# The Sizewell C Project

## 8.14 Water Framework Directive Compliance Assessment Report Addendum

Revision: 1.0  
Applicable Regulation: Regulation 5(2)(q)  
PINS Reference Number: EN010012

January 2021

**Plate 2.1: Proposed temporary BLF**

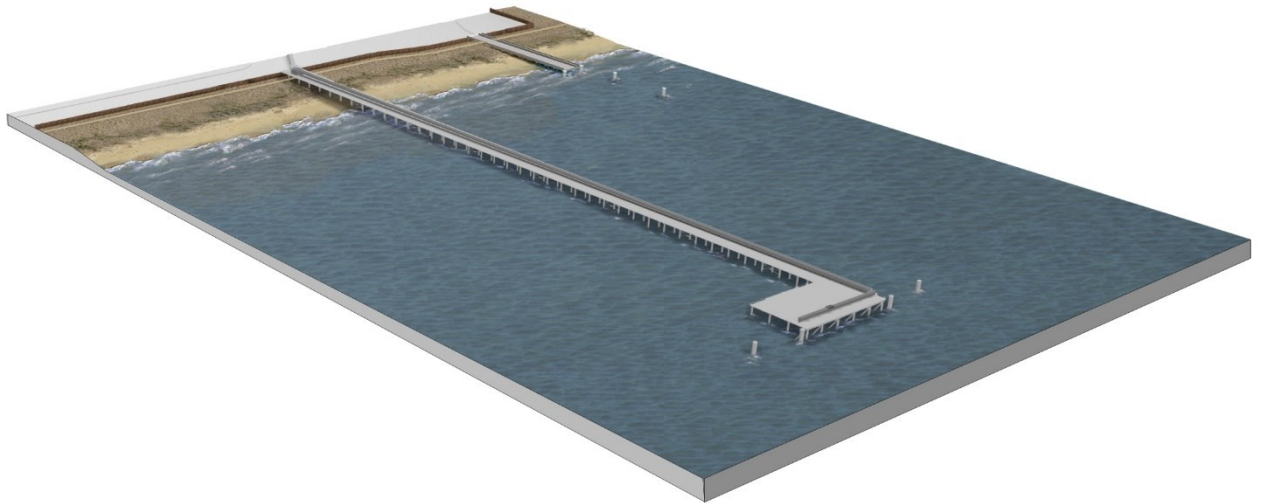
2.3.6 The temporary BLF would potentially be in place up to 2030 to be available to help manage the peak requirement for aggregates and other bulk materials. It would be located to the south of the enhanced permanent BLF.

2.3.7 The temporary BLF would be up to approximately 505m in length and up to approximately 12m in width for the main jetty. An enlarged unloading area would form a jetty head with dimensions of up to approximately 62m in width. A single berth (for a single vessel) is assumed at its seaward end. The structure would be a visually recessive colour as far as reasonably practicable.

**Plate 2.2: Revised SSSI crossing**

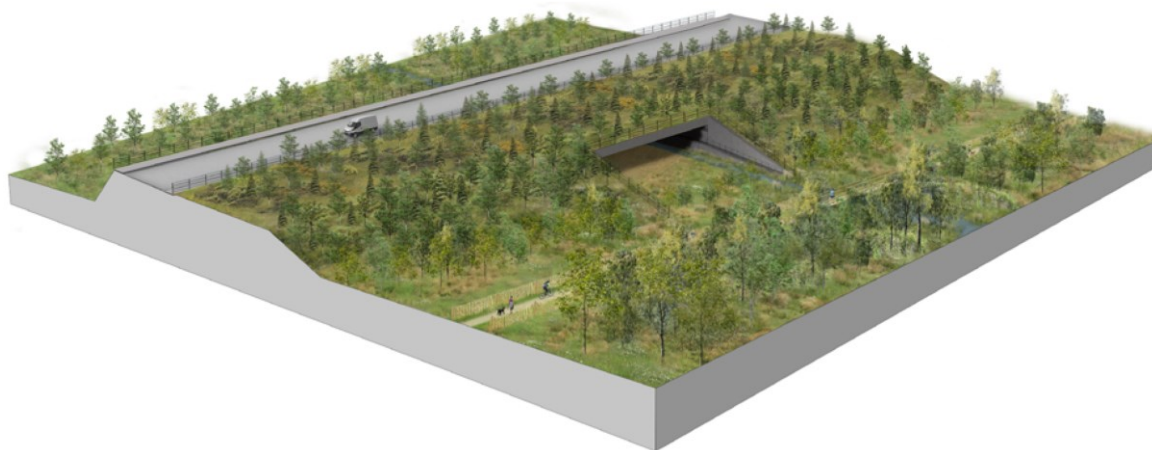
2.4.2 SZC Co. proposes to change the design from an embankment and culvert to comprise separate embankments at either end of the SSSI crossing with a 30m long single-span bridge connecting them (**Plate 2** Error! Reference source not found.). A sheet pile barrier wall would be driven into the ground either side of the Leiston Drain, with the total distance between the walls being approximately 24m. The bank and channel of Leiston Drain would be unaffected. The bridge abutments would be offset from Leiston Beck by approximately 1.2m on the north bank and approximately 21m on the south bank. The bridge deck would have a width of 40m, and the base of the embankment would have an overall width of approximately 70m. The deck would be set at a height of 4.75m above the floodplain.

2.4.3 The bridge design would retain significantly more space around the Leiston Beck and would reduce the amount of permanent SSSI land take by approximately 0.02ha. The change provides additional flood relief by reducing the amount of floodplain loss (to 5700m<sup>2</sup> within the footprint of the bridge abutments and embankment during the 1:100 year flood), which

would reduce water levels during times of increased flood risk compared with the current design.

**Plate 2.3: Proposed fen meadow habitat creation area**

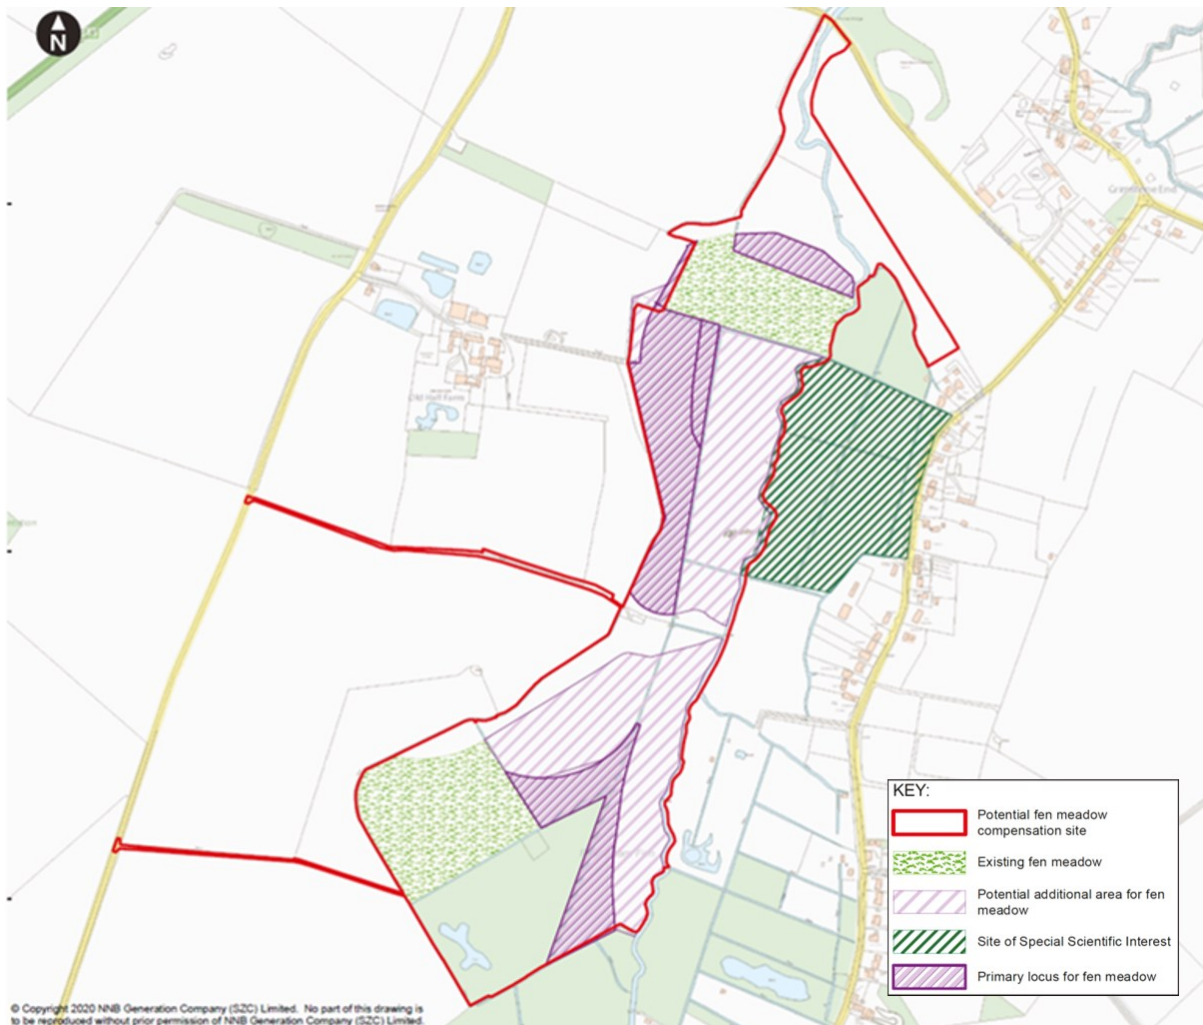
- 2.5.2 The site has been identified as being potentially suitable as it lies in a shallow basin bisected by the Pakenham Stream, and is in close proximity to other areas of fen meadow habitat. The site can be distinguished as two parts, 'north' and 'south', that lie either side of a 'tongue' of upland that divides the surface hydrology. A total of 4.9ha is considered the primary area for the creation of new fen meadow habitat, and some of the wider areas on the site may also have the potential for the creation of new fen meadow habitat.

- 2.5.3 The primary area for fen-meadow creation in the north part of the site is along the western slope and around the north side of an existing area of fen meadow, which together comprise an approximate area of 3.2ha. If control is exerted over the central drain, then large areas of rush pasture and improved grassland also have the potential to act as fen meadow compensation.

**2.5.4** The greatest potential for developing fen meadow on the south part of the site lies in controlling the internal ditches connected to the central drain, which would encompass an approximate area of 1.7ha. The potential also exists to detain water in the topsoil within the surrounding improved grassland. Further studies will be undertaken to confirm suitability.

**Plate 3.1: Pipeline transfer connection to Sizewell C**

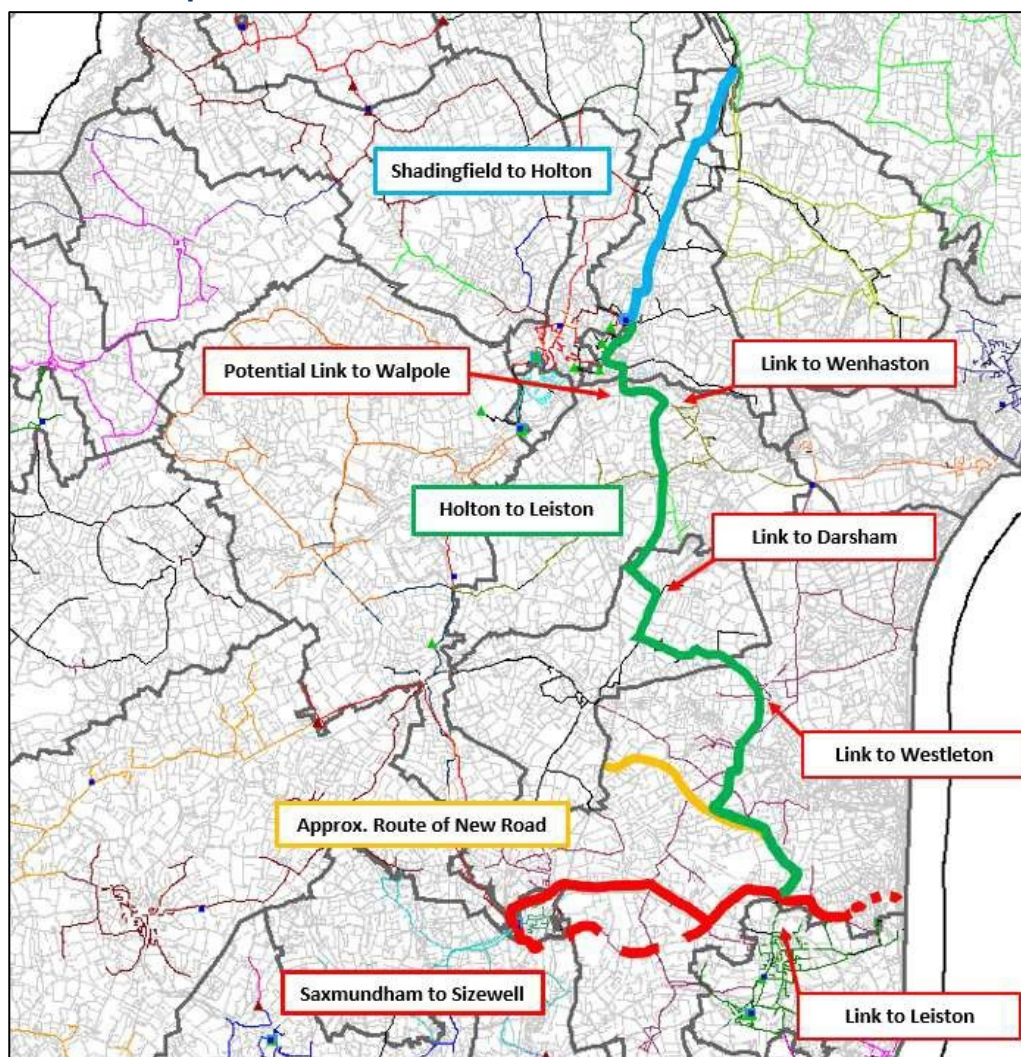
- 3.5.9 The principal supply for the Sizewell C Project is unchanged from the original **Site Water Supply Strategy** (Doc Ref. 8.4) [APP-601] and is assumed to come from mains water transferred via a new pipeline transfer connection from the Northern/Central Water Resource Zone. This scheme would be provided by Essex and Suffolk Water and does not form part of the Application.
- 3.5.10 The scheme proposed would provide a direct link from Barsham to Sizewell (**Plate 3.1**: Pipeline transfer connection to Sizewell C ).
